Comments on Draft report- E on- Kentucky Utilities- Pineville Generating Station

Re: Kentucky Utilities' Comments on
DRAFT Report of Geotechnical Investigation Dam Safety Assessment of Coal Combustion Surface
Impoundments Kentucky Utilities, a Subsidiary of E.ON U.S. Pineville Generating Station, Pineville, Kentucky

**KU Comments-clerical and technical corrections to
*DRAFT Report of Geotechnical Investigation Dam Safety Assessment of Coal Combustion
Surface Impoundments*
Kentucky Utilities, a Subsidiary of E.ON U.S.
*Pineville Generating Station, Pineville, Kentucky***

Table 1

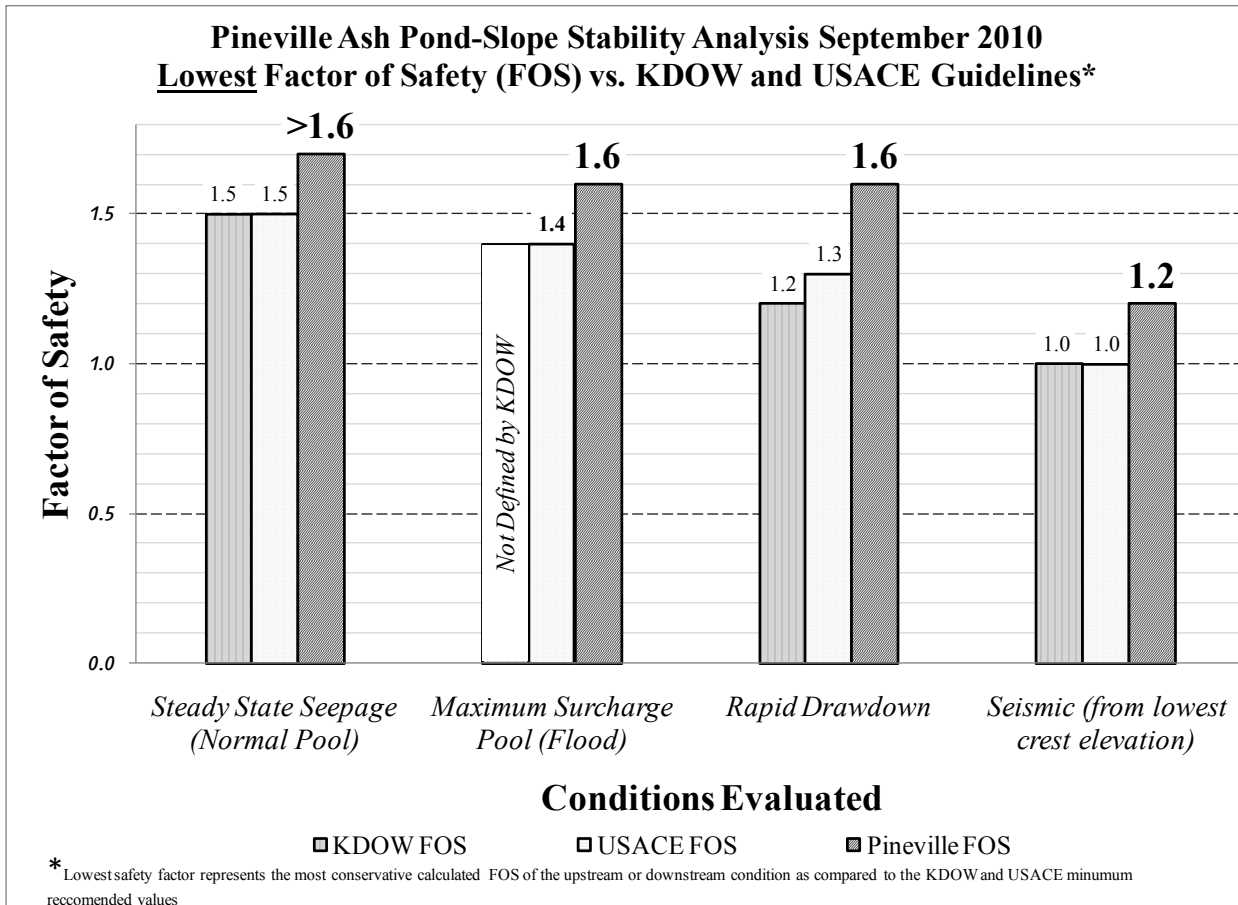
KU Notes: A comprehensive geotechnical exploration and slope stability analysis for the Pineville Ash Pond was completed in September, 2010 and is included as attachment 2. The results of the analysis are summarized in Table 1.
